APPLICATION NO.	FILING DATE	FIRST NAMED INVENTOR	ATTORNEY DOCKET NO.	CONFIRMATION NO.
09/725,470	11/30/2000	Sang-Duk Lee	6192.0169.AA	1695

## Office Action Summary

## DETAILED ACTION

FIG. 2

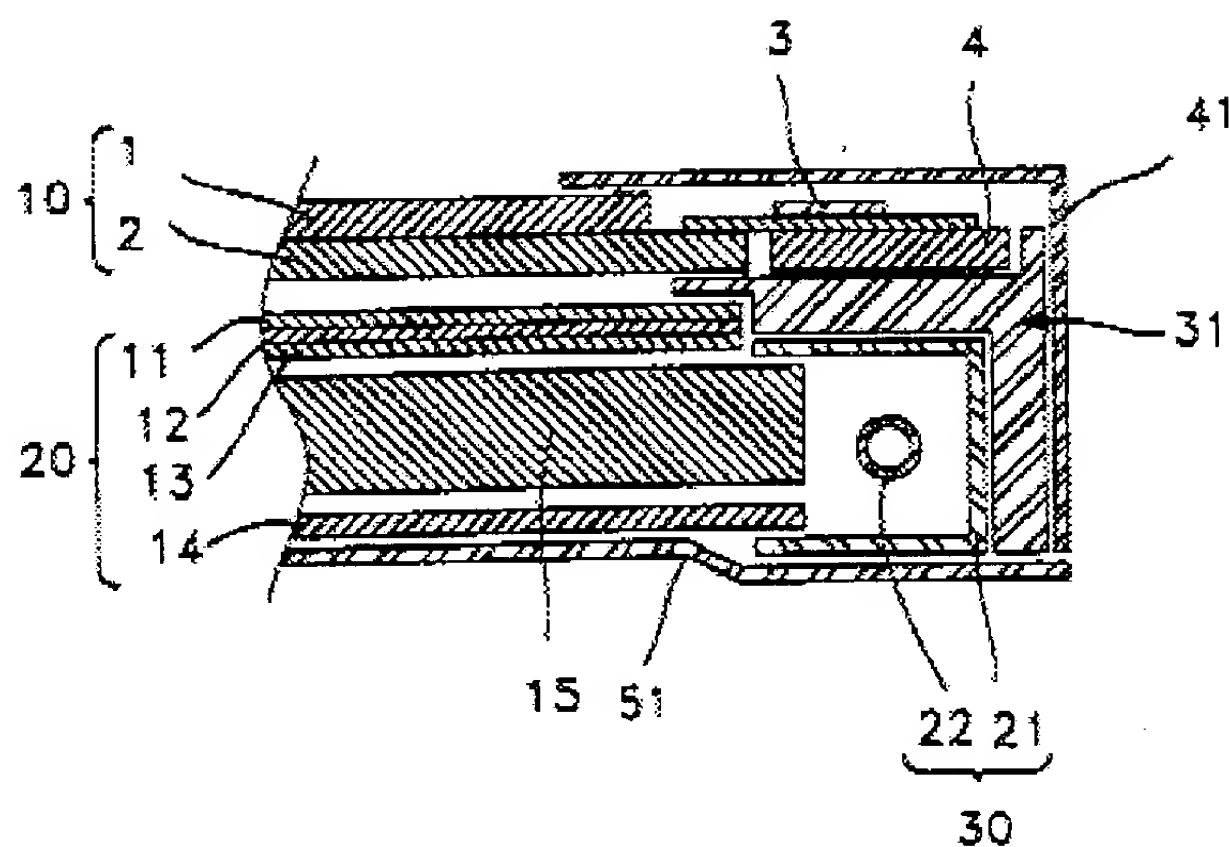
As to claims 1, 3, 4, and 27, Lee discloses in Figure 2 a liquid crystal display (LCD) device, comprising: a liquid crystal display panel, 1 and 2, and a flexible printed circuit (not labeled item between 2 and 3), attached to said liquid crystal display (LCD) panel, for applying driving signals to said liquid crystal display panel; a light guide plate and lamp assembly, 15 and 30, (Applicant's back light assembly) for providing a light to said LCD panel; a mold frame for receiving said liquid crystal display panel and said back light assembly; a chassis, 41, coupled to said mold frame, for fixing said liquid crystal display panel and said back light assembly to said mold frame.

Lee does not explicitly disclose a support means for supporting said flexible circuit board towards said mold frame.

**FIG. 4**

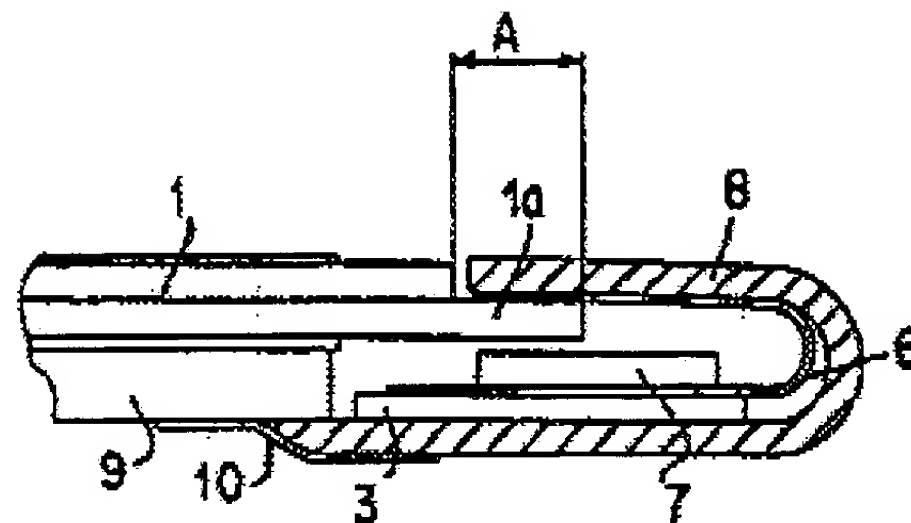
Figure 4 of Hashimoto shows a liquid crystal display panel comprising: a flexible printed circuit, 6, which is attached to the liquid crystal display panel, for applying driving signals to said liquid crystal display panel which is curved into a recess which is deeper in the upper end of the outer side (Applicant's receiving recess) to receive a protruding portion, 7, in order to minimize weight and size (summary of the invention, col. 2, line 31 through col. 3, line 26) and to protect the circuits (col. 5, lines 4-17); and a frame member, 8, that has a moderate level of resiliency for nipping the liquid crystal display panel, 1, and the circuit board, 3, (col. 5, lines 58-68) (Applicant's support member for supporting the flexible circuit board towards the mold frame) to provide greater durability and resistance to vibration and impacts.

Hashimoto is evidence that ordinary workers in the art of liquid crystals would find the reason, suggestion, or motivation to add a flexible printed circuit board curved into a recess which is deeper in the upper end of the outer side to receive a protruding portion, and a support means to protect the circuits and to provide greater durability and resistance to vibration and impacts.

(1) It is respectfully pointed out that integrated circuit, 7, is cited as a protruding portion of the flexible circuit board that is supported by the moderate level of resiliency (spring action) of frame member, 8, per Page 4 of the final rejection.

duplication of parts requires only routine skill in the art. Please note that curved portion of the flexible printed circuit of Hashimoto passes through vertical (Applicant's substantially perpendicular to the liquid crystal display panel). Consequently, Applicant's structure as broadly claimed is rendered obvious, to those having ordinary skill in the art of liquid crystals at the time the claimed invention was made, by Lee in view of Hashimoto per rejections above.
